DEPARTMENT OF GENERAL SERVICES, PURCHASING DIVISION

ADDENDUM # 8

CAPITAL PROJECT 3414: CONSTRUCTION OF NEW HIGHWAY FACILITY

Questions and responses to RFI's #4, 7, 11, 12, 15, 16, 17, 19, 20, and 21. Questions and answers 27 through 76.

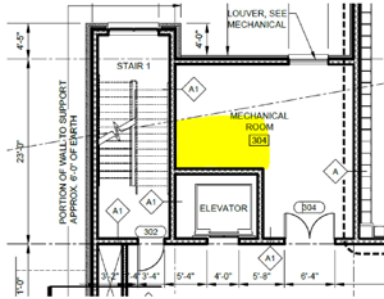
- c. Is the hoist single speed or two speed? Please clarify.

Response: Both the hoist and trolley are to be single-speed.

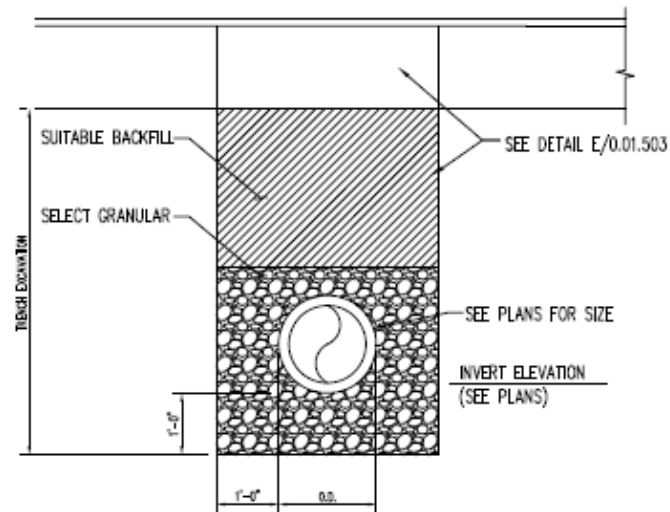
40. Based on our initial earthwork model, the site is a net import. During the site walk it was mentioned that regardless of what our earthwork model results are, the site is balanced and grade adjustments will be made to ensure that it becomes a balanced site. Please confirm we should bid the project assuming a bulk earthwork balance. **(NB04)**

Response: Yes, project should be bid assuming that the bulk earthwork will balance.

A **PIPE TRENCH EXCAVATION & BACKFILL (HDPE & PVC)**
 SK-1 N.T.S.

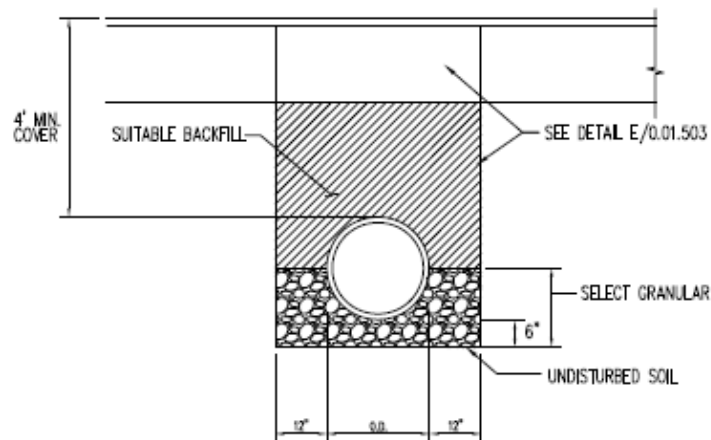
42. Drawing #0.01.503 Detail E – Trench Pipe references "See Trench Sections". Please advise on where this information can be found. **(NB04)**

Response: See attached detail sketches, which will be added to Addendum drawings.
